**YARRA CITY COUNCIL**  
**Internal Development Approvals Committee**  
**Agenda**

**1.1 PLN15/0426 - 8 Peckville Street, Clifton Hill - Development of the land for full demolition and construction of three, two storey dwellings.**

1. This report provides Council with an assessment of a planning permit application submitted for 8 Peckville Street, Clifton Hill which seeks approval for development of the land for full demolition and construction of three, two storey dwellings. The report recommends approval, subject to conditions.

Image: insert of sketch plan indicating introduction of side setback to the north first floor wall.

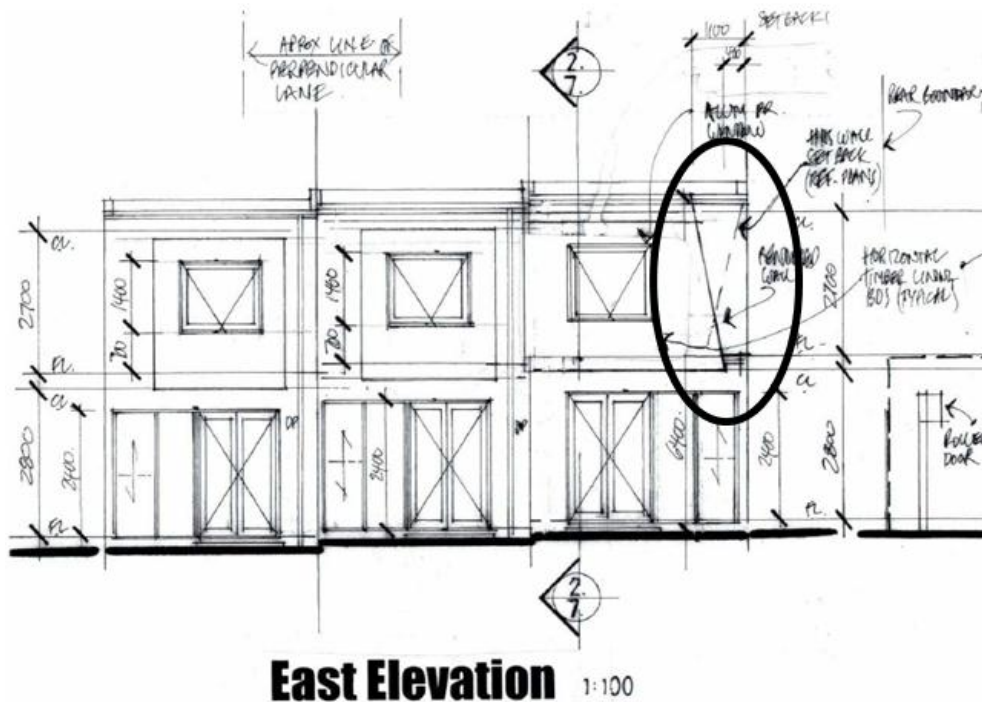
161. The main on-boundary wall impact to consider is at the first floor, which extends to 6.5m high for a length of 3.8m. Although this wall does not interface with the full length of the adjoining SPOS, the affected SPOS is modest in size and a two storey concrete wall on the boundary for this length would be unreasonable in terms of visual bulk. Of note, the wall interfaces with the wider (and possibly the more useable) part of the SPOS on the adjoining property. To address this, the Applicant has submitted sketch plans that incorporate a setback/rake and alternate material finish as depicted in the image below.

162. The proposed modifications include a raked wall, which would be setback at the first floor level 0.4m from the boundary, with the rake extending to a setback of 1.1m from the boundary at the top of the wall. To facilitate this setback and maintain a reasonable bedroom size and internal amenity, the southeast corner of the subject bedroom has had the floor extended by an area of 0.6m by 0.6m to fill the void immediately south of the bay-window. This is appropriate as it is internal to the site and has no direct interface with adjoining properties.

163. The standard requires a 1.87m setback based on a wall height of 6.5m. However it is acknowledged that the site is located within an inner-city context where shallower setbacks are not uncommon and the proposed development is positioned to the south of the adjoining property, thereby avoiding any overshadowing impacts. In terms of a response to minimising visual bulk concerns, setting back the first floor north wall to bedroom 1 of the northernmost dwelling between 0.4m to 1.1m through provision of a rake is considered an appropriate setback. An alternative material compared to blank concrete in the form of timber cladding would also go a long way to alleviate the perception of bulk, with the first floor material being more recessive compared to the ground floor wall. This is accepted to be a reasonable balance between allowing development on the subject site within an inner-city context and ensuring that any amenity impacts to adjoining sites are not unreasonable. In addition, inclusion of a highlight window or skylight (that complies with the overlooking objective of the Scheme) would also aid in effectively breaking-up the built form, add visual interest and also provides northern light access to the bedroom. A condition of the permit will require the wall setback, material changes and provision of a highlight window/skylight.

- (j) The north and east first floor walls to bedroom 1 (of the northernmost dwelling) finished in timber cladding;
  - (k) Provision of a highlight window or skylight to the first floor north wall of bedroom 1, which also complies with clause 55.04-6 (overlooking objective) of the Yarra Planning Scheme;
